Service Bulletin

R1701

Model Year 2017 Retrofit - Surge Tank

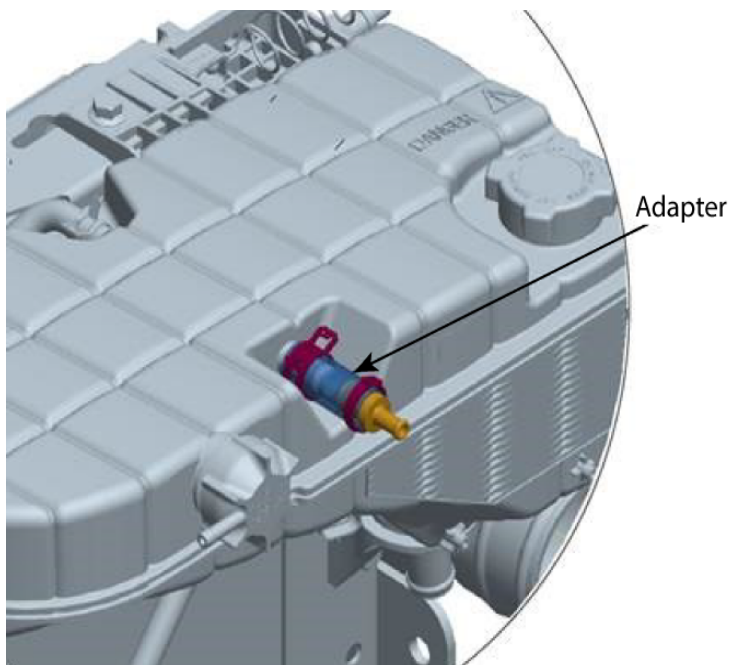
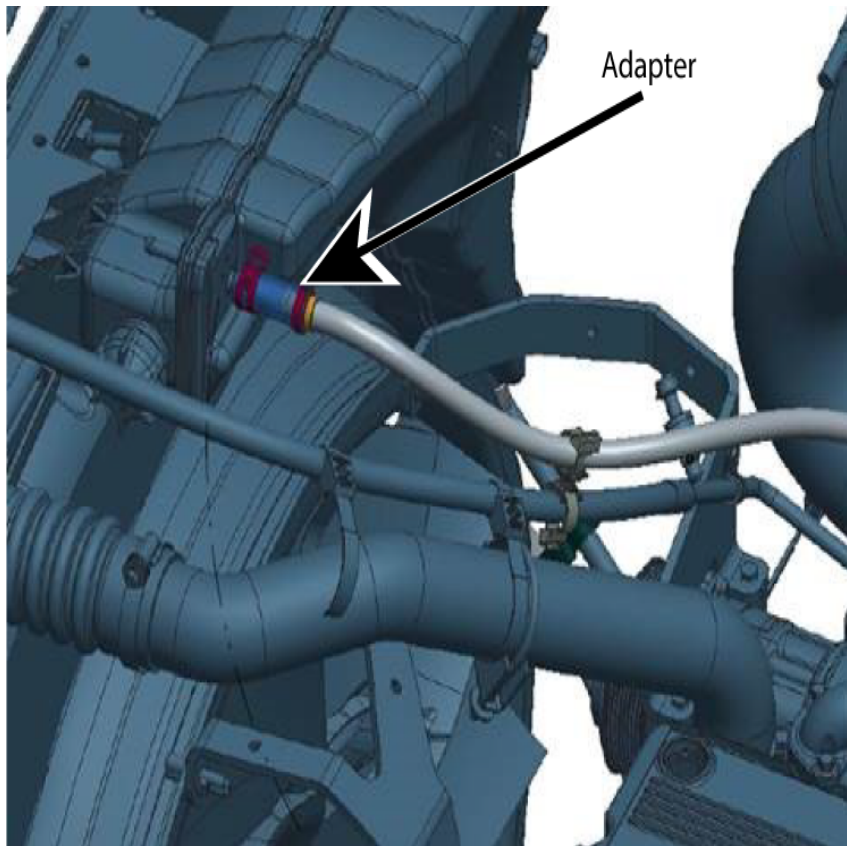
1. Drain the coolant into a clean container. The coolant will be reused.
2. Remove the surge tank.
3. Install the new surge tank.
4. Install the adapter on the surge tank as shown in the following images.

5. Connect the hose from the engine to the adapter on the surge tank.
6. Fill the cooling system with the removed coolant.
